**RE: LUDINGTON PUMPED STORAGE HYDROELECTRIC PROJECT
(FERC PROJECT NO. 2680-113)**

**RESPONSE TO JULY 27, 2017 STAFF COMMENTS ON FINAL LICENSE
APPLICATION**

CONSUMERS ENERGY COMPANY &
THE DTE ELECTRIC COMPANY
LUDINGTON, MICHIGAN
LUDINGTON PUMPED STORAGE PROJECT
BARRIER NET
PLAN AND DETAILS
FERC PROJECT NO. 2680

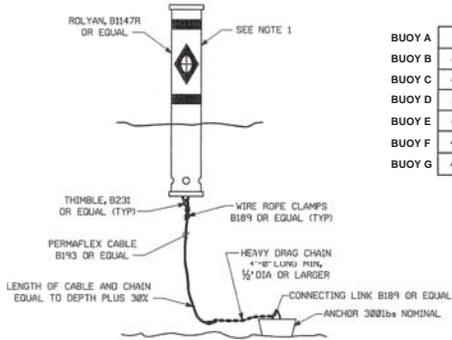
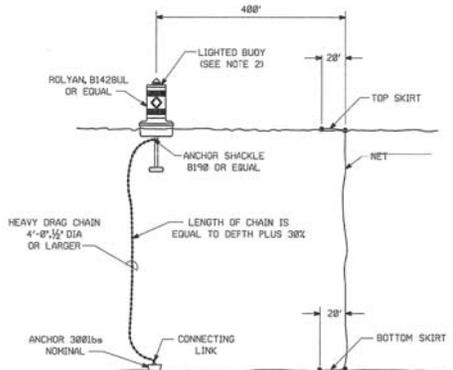
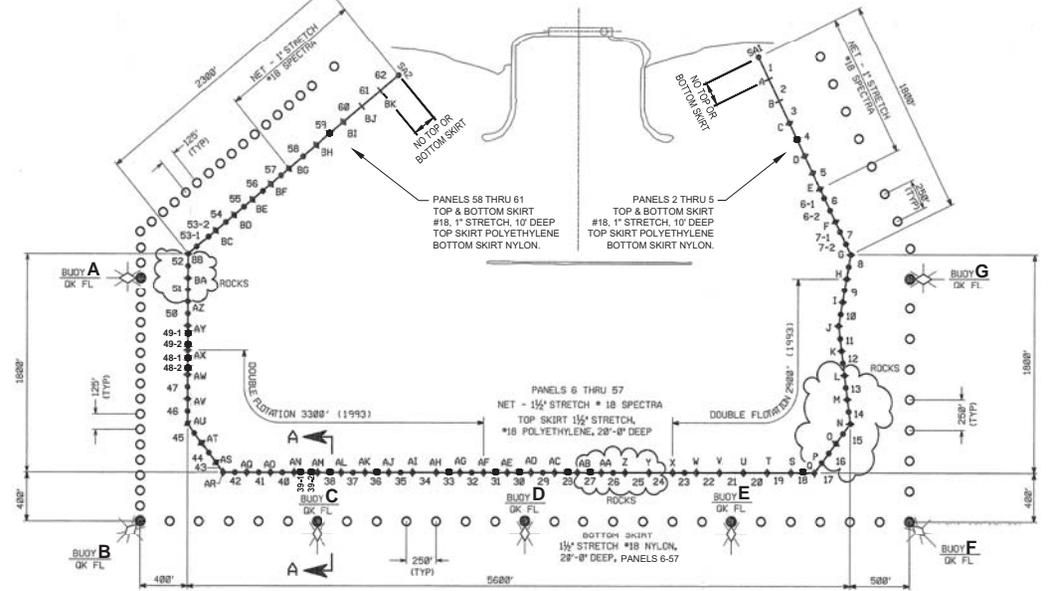
- (2) Exhibit A, page A-2-1 of the FLA gives the Lake Michigan water surface elevation as 581 feet National Geodetic Vertical Datum (NGVD) 29, but Exhibits F2 and F4 state this elevation as 579.5 feet. The Exhibit Fs do not contain a note specifying which datum is used, although we assume it is also NGVD 29. Please reconcile this difference throughout the application as necessary.

- (22) The Exhibit F drawings provided in the FLA do not reference the vertical datum. Please show a vertical datum on each sheet that depicts a section or profile drawing. The datum should match the one referenced throughout the FLA.

included a note (located above the title block in the lower right hand corner) indicating that all elevations were based on NGVD 29. The only exception being Exhibit F sheet F7, depicting the barrier net details, this drawing does not refer to specific elevations and thus does not require the note to be added. Revised Exhibit F drawings are filed separately as they contain CEII.

Plan View - Sheet 1 of 1

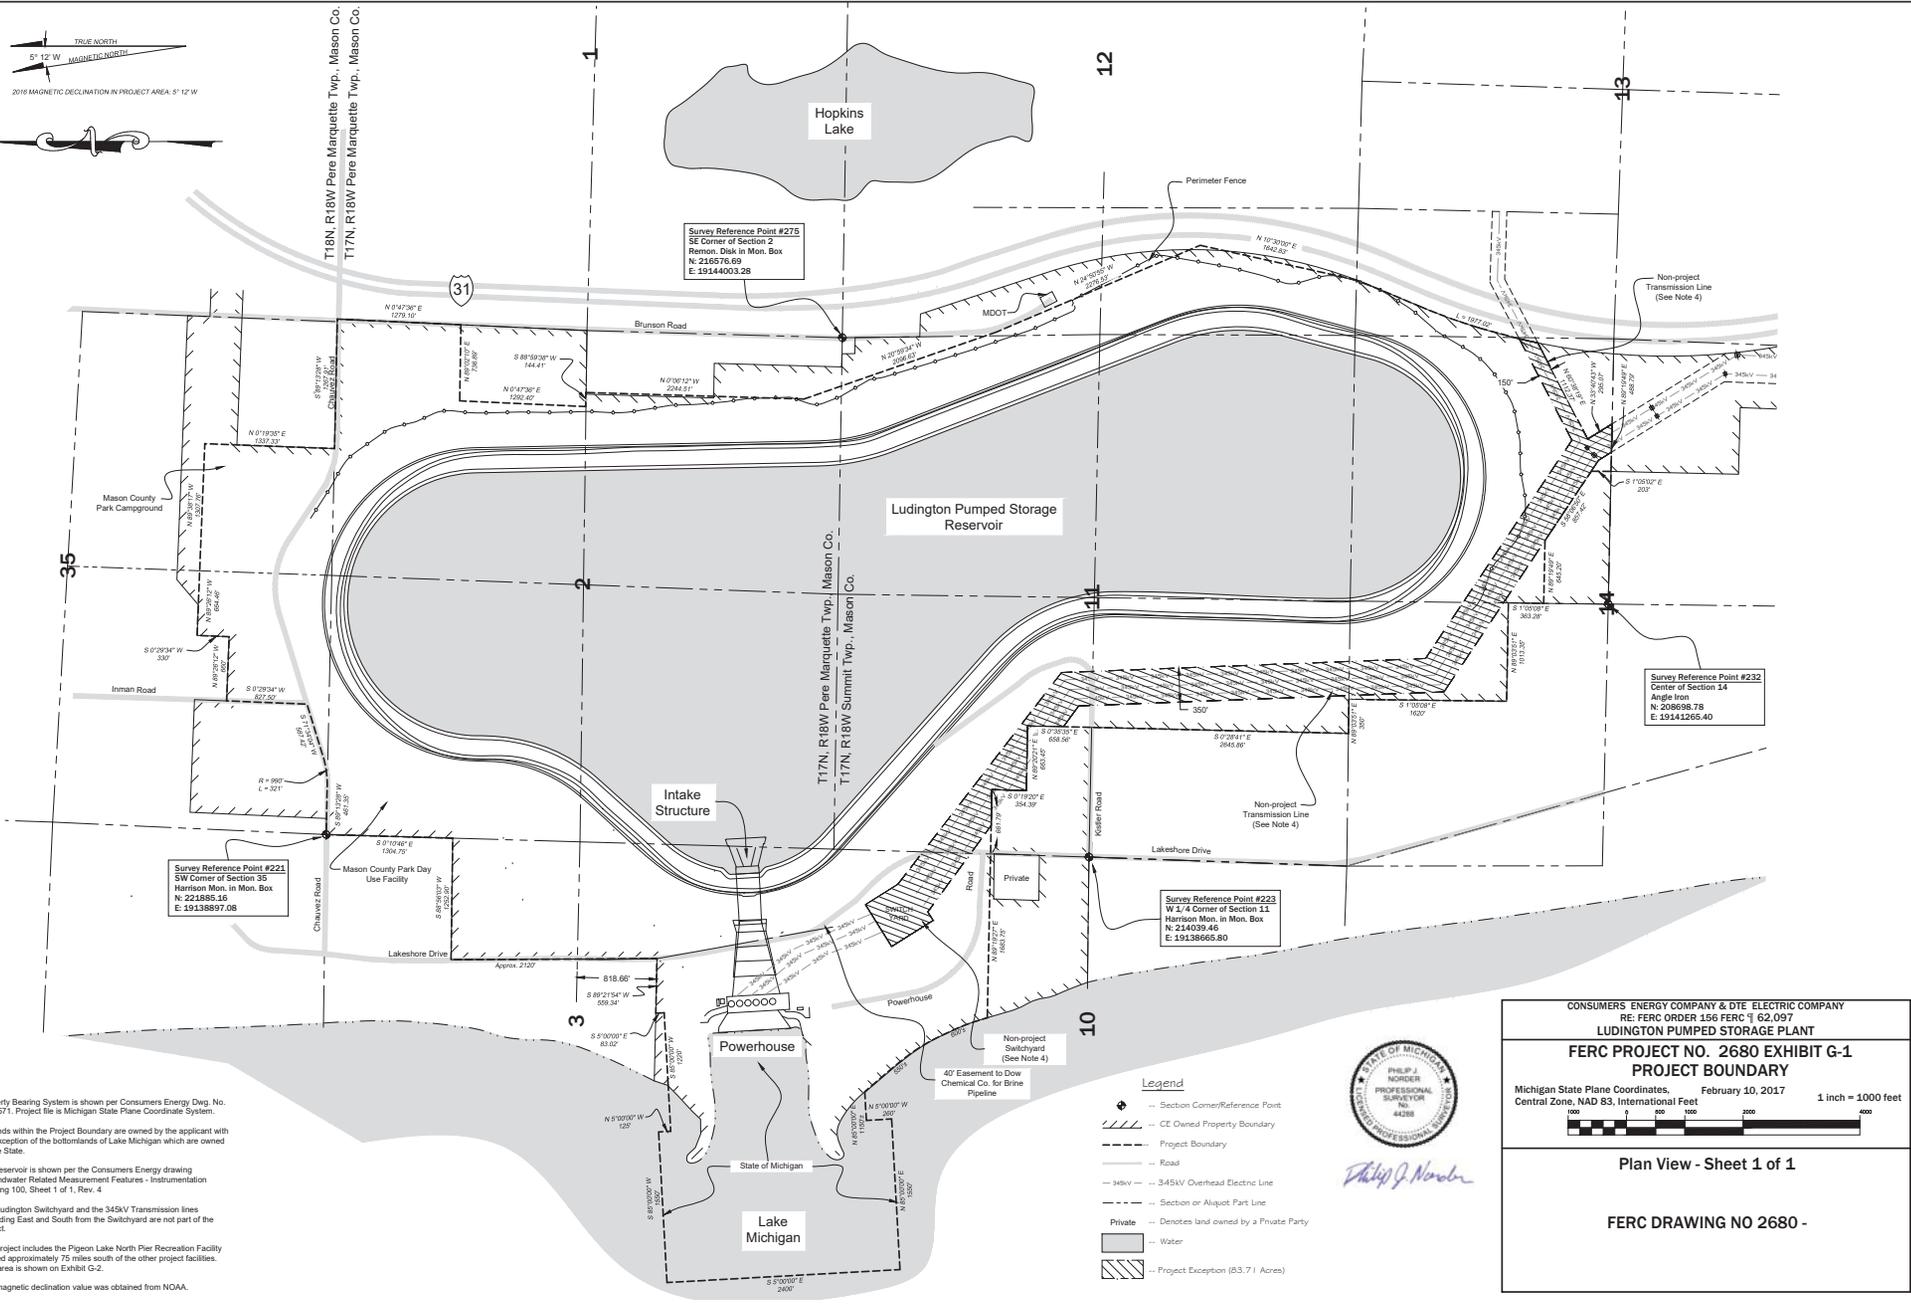
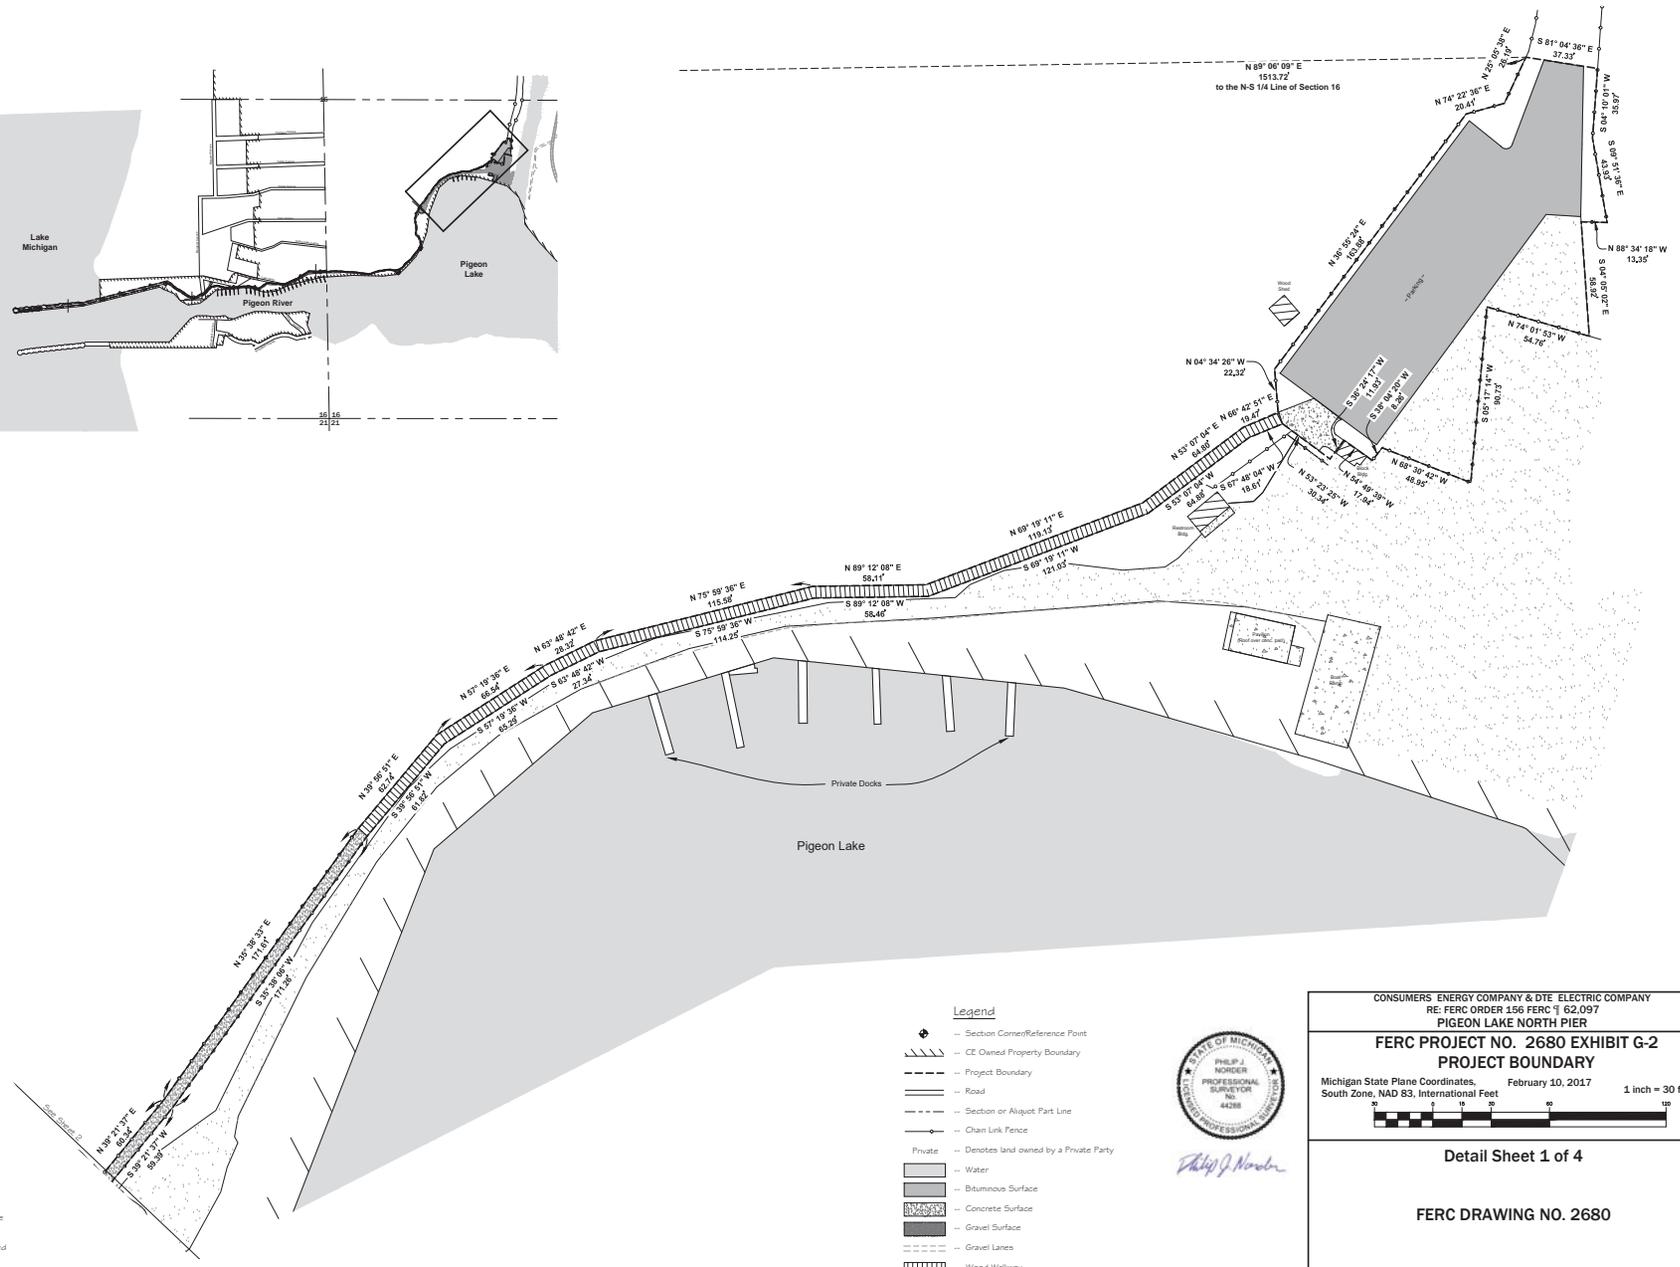
- (4) Section 4.39(b)(1) of the Commission’s regulations requires each Exhibit G map to show the true and magnetic meridians. Please provide this information.

- (23) Exhibit G-1 shows the project boundary for the Upper Reservoir and powerhouse. However, in the area depicted on Exhibit G-1, land near the removed right-of-way for the Ludington Project's switchyard and the 345 kV transmission lines, the project boundary is unclear. Please clearly identify the project boundary in this area on your Exhibit G-1 and provide the rationale for the boundary line.

Revised Exhibit G maps are attached. Each sheet now includes the required true and magnetic meridians as required.

The area excluded from the project boundary for the transmission corridor has been more clearly defined on the revised Exhibit G-1 drawing. The transmission line corridor is a strip of land 350 feet wide centered along the transmission line pathway as depicted on the revised Exhibit G-1 drawing. Ordering paragraph F(b) of the February 1, 2001 FERC Order (94 FERC ¶ 62, 122) approving the removal of the transmission line from the project boundary states:
